City of El Paso – City Plan Commission Staff Report

Case No: SUSU17-00072 Singh Addition Second Section Replat A
Application Type: Resubdivision Combination
CPC Hearing Date: November 16, 2017
Staff Planner: Brenda R. Cantu, (915) 212-1642, cantubr@elpasotexas.gov
Location: North of Americas and West of Alameda
Acreage: 0.4991
Rep District: 6
Existing Use: Residential
Existing Zoning: R-4 (Residential)
Proposed Zoning: R-4 (Residential)
Nearest Park: SPC Adrian Garcia Park (.33 miles)
Nearest School: South Loop Elementary (.35 miles)
Park Fees Required: \$5,480.00
Impact Fee Area: N/A
Property Owners: Christian Alderete
Applicant: Christian Alderete
Representative: CAD Consulting Company

ATTACHMENT 6

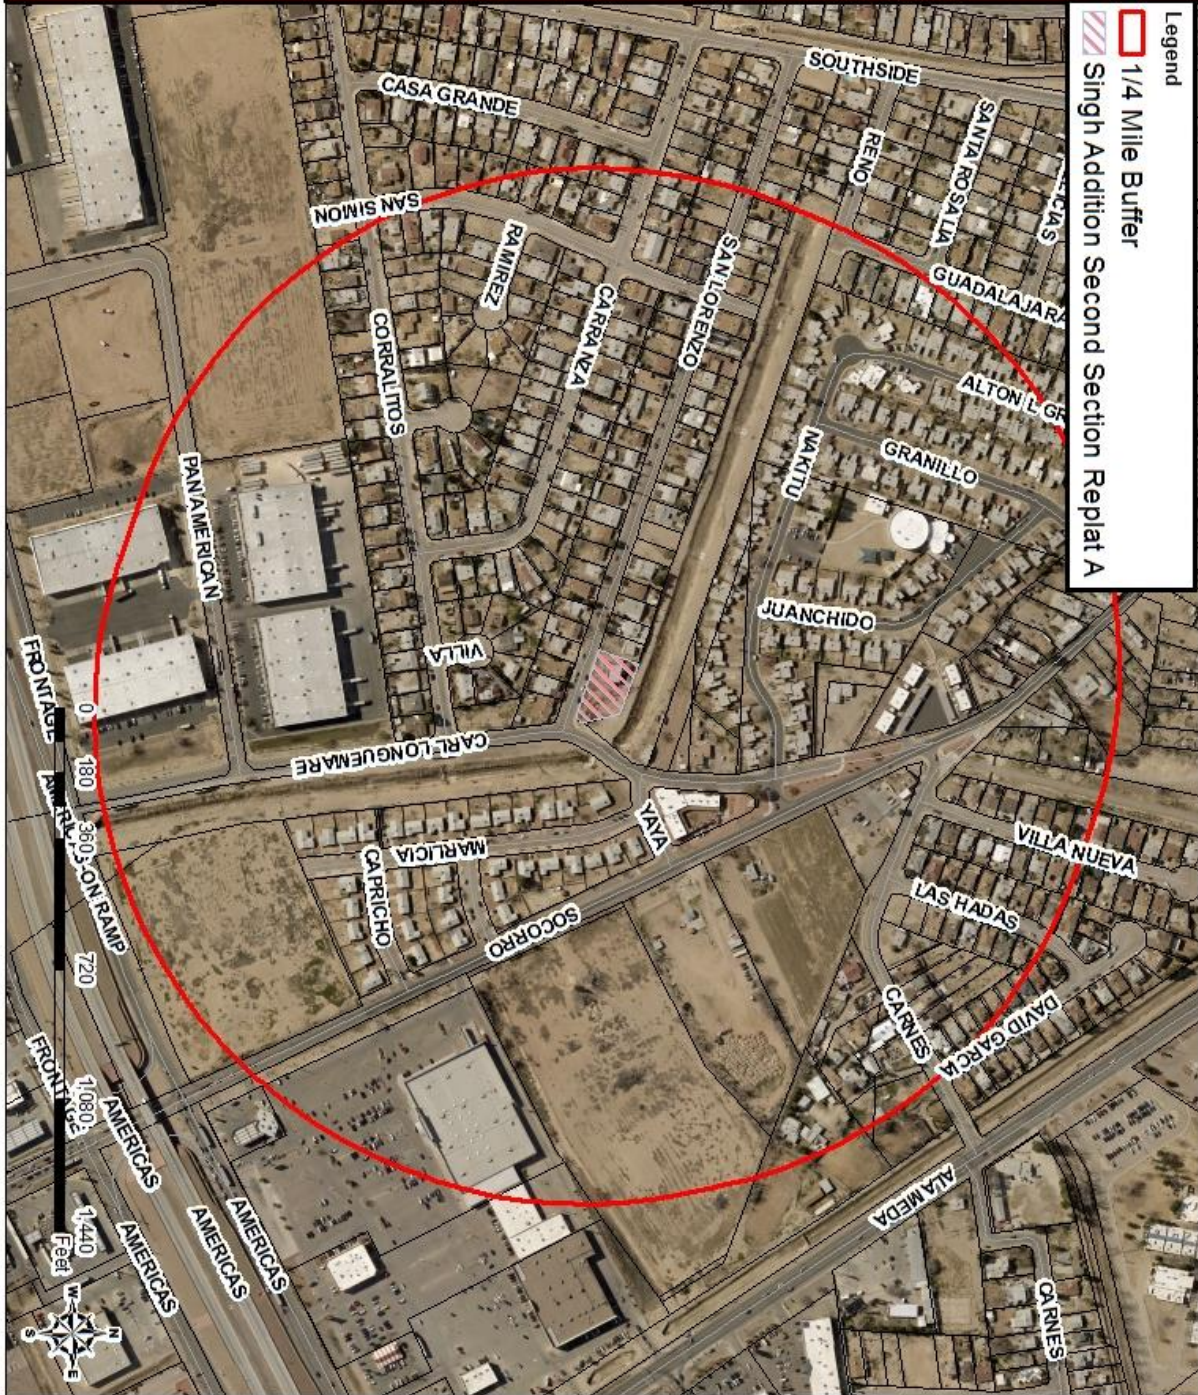
- To waive the 5' landscape parkway along San Lorenzo Drive.
 - Currently, there is only a 7.5 sidewalk within the parkway as there is no room for a landscape parkway.

This is a request for a waiver for the property on 9379 San Lorenzo Avenue (Singh Addition Second Section Replat A) on the request from the City of El Paso Planning and Transportation comments regarding roadway improvements and right-of-way width. This is as per Section 19.10.050.a1a, because all of the street has existing sidewalks and curbs and the existing right-of-way width as per the recorded plat is 50 feet instead of 52 feet as required.

The applicant's proposal to waive the 5' landscape parkway is in character with the area since most surrounding properties do not have a landscape parkway and the sidewalks abut the curb. Additionally, more than 50% of the properties have been developed.
